**MEMORANDUM
 PLANNING AND URBAN DEVELOPMENT DEPARTMENT
 PLANNING DIVISION**

To: Sean Dundon, Chair, and Members of the Portland Planning Board
From: Nell Donaldson, Senior Planner, and Caitlin Cameron, Urban Designer
Date: October 19, 2018
Re: MMC Congress Street Hospital Building
Project #: 000331-2018 **CBL:** 53-D-7
Meeting Date: October 23, 2018

Figure 3: Preliminary site plan

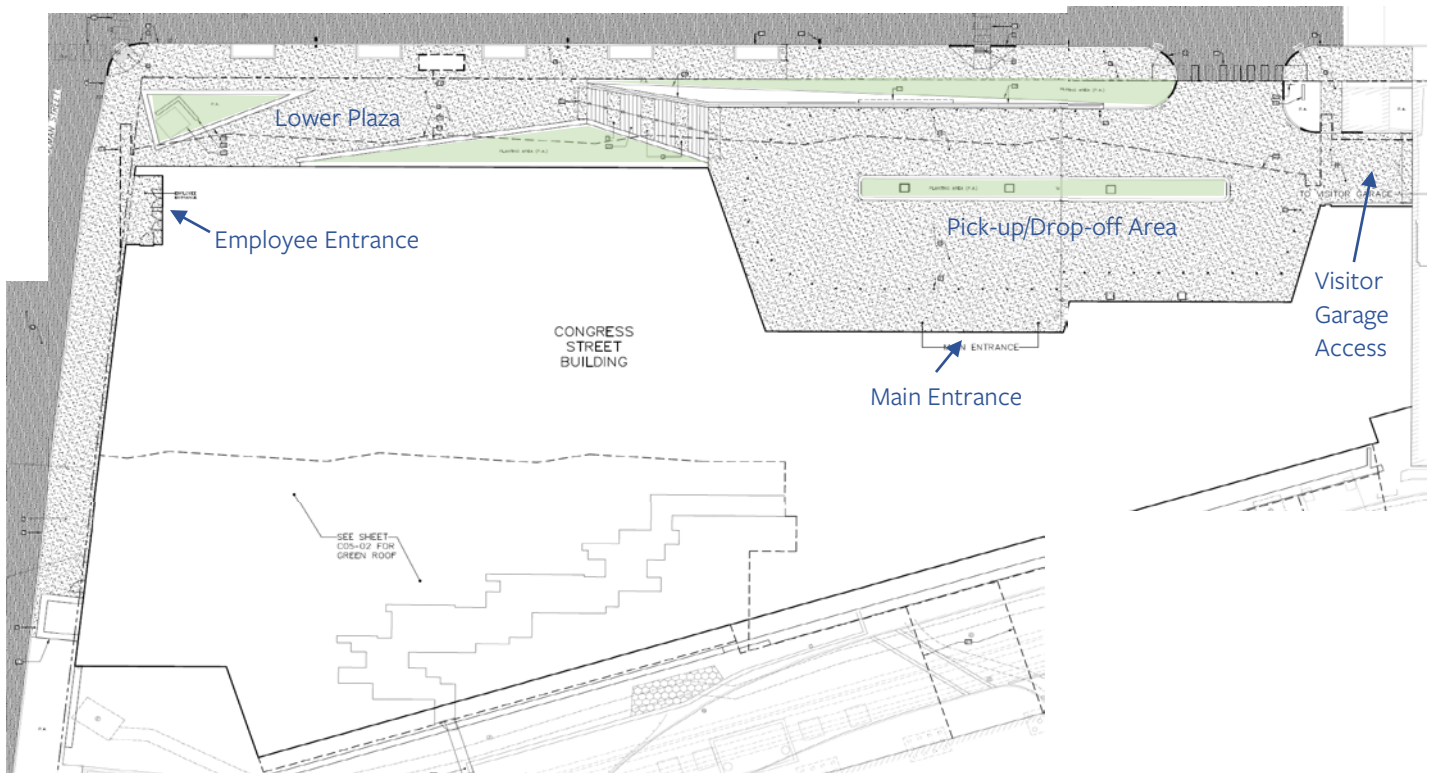
1. *Sidewalk width and sidewalk design:* The effective width of the proposed Congress Street sidewalk varies between approximately 3' at the area with a perpendicular crosswalk, 6' at areas with tree wells, and 11' elsewhere. Staff has requested that the applicant explore options to widen the sidewalk to allow more a generous pedestrian zone. Staff has also raised questions about the width of the Gilman sidewalk as it is proposed to taper near Congress. Tom Errico, the city's consulting traffic engineer, writes,

General sidewalk width given future pedestrian demand on Congress Street seems inadequate. Congress Street cross-section width should specifically be detailed. How will bikes, parking, bus, vehicles be accommodated?

The flared curb ramp near the main entrance vehicle driveway is not acceptable partly because it creates a narrow pedestrian accessible route. Also, the crosswalk location should be evaluated.

The provision of the City’s preferred two ramp configuration at the Gilman Street corner should be investigated.

The Gilman Street non-tangent curb alignment is not acceptable. A straight curb is suggested. Gilman Street width dimensions shall be provided.

I don’t believe, based on the grading plan submitted, (C40-01/02) that the curb ramps serving the mid-block crosswalk meet ADA in terms of cross-slope (2% max. cross-slope) nor that the area shown for the bus stop has a bus landing area that meets ADA. Please document the ADA analysis.

I need to further assess curb ramp design- for instance, there is not sufficient landing area for the curb ramp serving the mid-block crossing along the retaining wall - a 5’ deep (measured perpendicular to the street) ramp landing area is required where a ramp meets vertical obstructions (not the usual 4’)

The site plan key identifies #14 as "Bus Stop" but the elevations show a bus shelter - there is not sufficient bus landing area (5'x8' minimum") provided if a bus shelter is intended (or unless the landing area includes a portion interior to the shelter as the landing area - which is not preferred).

No bus stop or shelter location is shown on the north side of Congress St as has been discussed with the applicant - a paired bus stop is desired.
